Technical Service Bulletin (TSB)

Camshaft Sensor DTC

REFERENCE:	TSB: 08-099-25 GROUP: 08 - Electrical 09 - Engine	Date:	April 4, 2025	REVISION:	—
VEHICLES AFFECTED:	2022 - 2023 (JL) Jeep Wrangler 2022 - 2023 (JT) Jeep Gladiator This bulletin applies to vehicles equipped with 3.0L V6 Turbo Diesel Engine W/ESS (Sales Code EXJ).			MARKET APPLICABILITY: ☒ NA☐ MEA ☐ SA☐ IAP ☐ EE☐ CH	
CUSTOMER SYMPTOM:	Customers must experience a Malfunction Indicator Lamp (MIL) illumination and the vehicle must exhibit/set the following Diagnostic Trouble Code (DTC): P0341 - Camshaft Position Sensor - Performance Bank 1 - Sensor 1.				
CAUSE:	Electromagnetic Interference on camshaft sensor due to mis-routed wiring

This bulletin involves repairing the cam sensor harness and re-routing the generator wiring.

Fig. 1
generator Field Harness

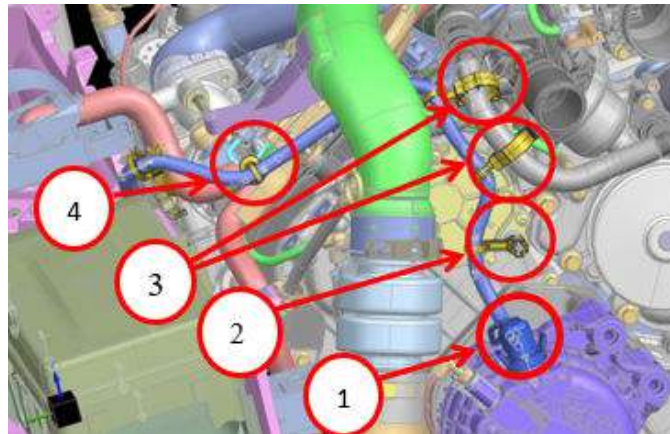
1. Disconnect negative battery cable. Refer to the detailed service procedures listed in DealerCONNECT> Service Library> Service Info under: 08 - Electrical / 8F - Engine Systems / Battery System / Standard Procedure.
2. Disconnect battery positive cable from generator [Fig. 1](#).
3. Remove stud clip, two C-Clips and fir tree clip from harness (four clips) [Fig. 1](#).

Fig. 2
Re-Routed Harness

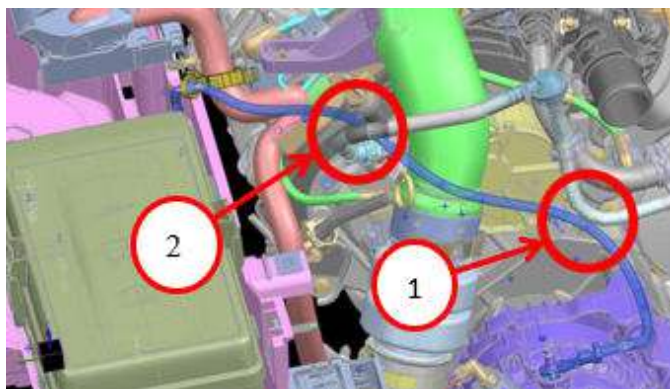
4. Re-route generator positive harness around the Charge Air Cooler (CAC) inlet hose and secure with two tie straps to brake booster vacuum hose [Fig. 2](#).

NOTE: Ensure harness is not in contact with sharp edges.

Fig. 3
Harness Wiring Orientation

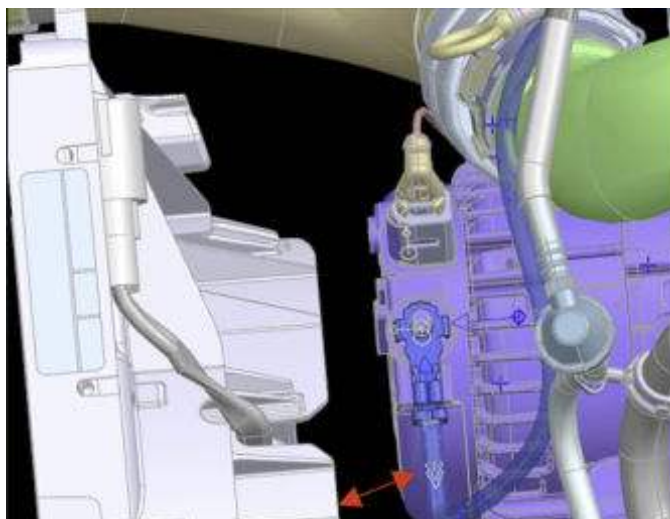
5. Reconnect battery positive cable to generator in new orientation (facing vehicle left) [Fig. 3](#).

NOTE: Ensure there is no excess slack and at least 25mm (1 in.) clearance to radiator fan shroud to any point of the generator positive cable harness.

Fig. 4
Cam Sensor Wiring harness

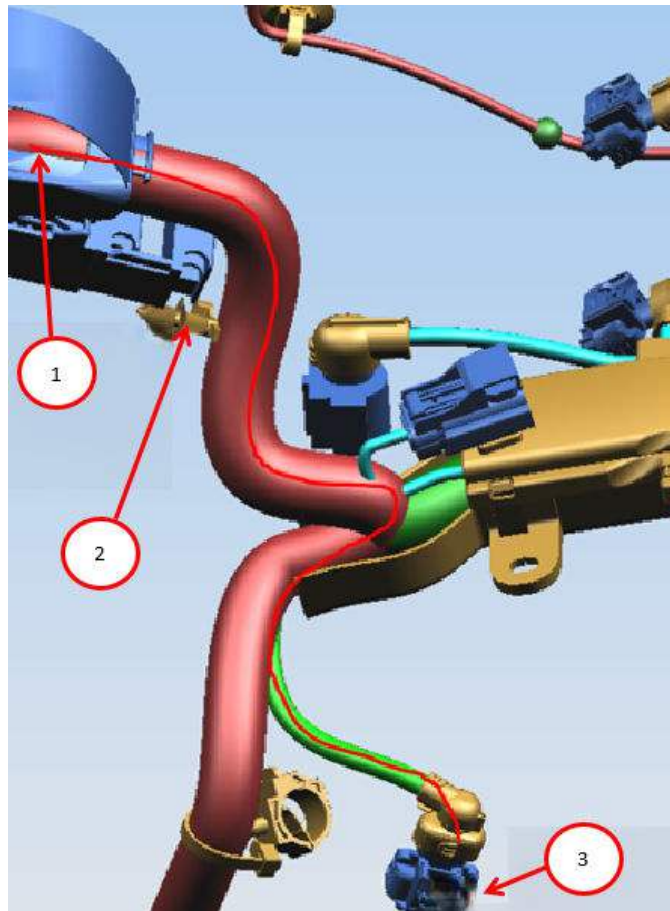
6. Disconnect the Powertrain Control Module (PCM) C2 connector at the PCM.
7. Remove the tie strap on the C2 harness trough [Fig. 4](#).
8. Remove the clip Raymond on C2 harness [Fig. 4](#).
9. Remove the tape on C2 harness [Fig. 4](#).
10. Extract the terminals from the Camshaft Sensor 3W connector [Fig. 4](#).

Fig. 5
PCM C2 Connector

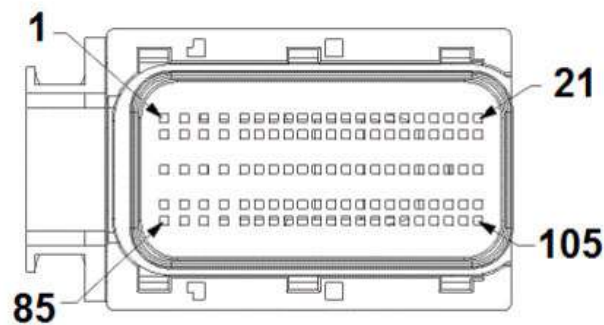
11. Locate pins 37, 52 and 51 of the PCM C2 connector [Fig. 5](#).

12. Trace and cut wires 37, 52 and 51 at different positions to avoid solder points in the same area.

Fig. 6
Camshaft Sensor Harness End

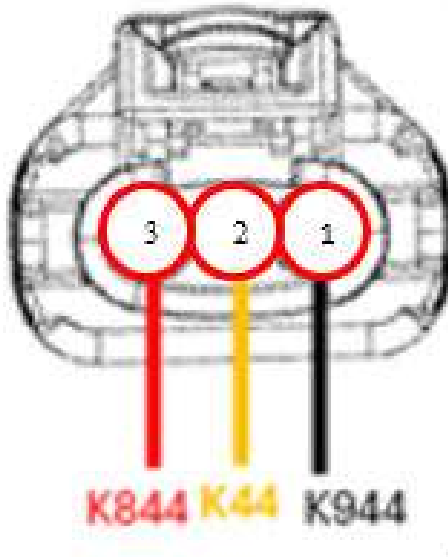
13. Strip the wires and solder to the with twisted pair jumper kit using the solder sleeves included in the kit (refer to the kit instructions).
14. Insert kit harness terminals inside the original Camshaft Sensor 3W connector.
15. Tape the harness back up.
16. Fix clip on PCM C2 branch and use a tie strap on the trough to hold the harness within the trough.
17. Reconnect the PCM C2 connector at the PCM.
18. Reconnect the negative battery cable. Refer to the detailed service procedures listed in DealerCONNECT> Service Library> Service Info under: 08 - Electrical / 8F - Engine Systems / Battery System / Standard Procedure.
19. Perform an electrical pin-to-pin test with multimeter to confirm the electrical continuity [Fig. 6](#).

- With ECU connector inserted and KEY-OFF – measure with an ohmmeter set to Ohms.
 - Pin 2 to Pin 1 (SIGNAL Out to SIGNAL/SUPPLY negative) = OL.
 - Pin 2 to Pin 3 (SIGNAL Out to SUPPLY) = OL.
 - With ECU connector inserted and KEY-ON – measure with a voltmeter, at least 100 mV resolution.
 - Pin 2 to Ground (SIGNAL Out) = Around 4.6 V.
 - Pin 3 to Ground (SUPPLY) = 5 V.
 - Pin 1 to Ground (SIGNAL and SUPPLY negative) = 12 V.
20. Turn the key off and reconnect the cam sensor harness connector.
 21. Clear all DTCs that may have been set in any module.
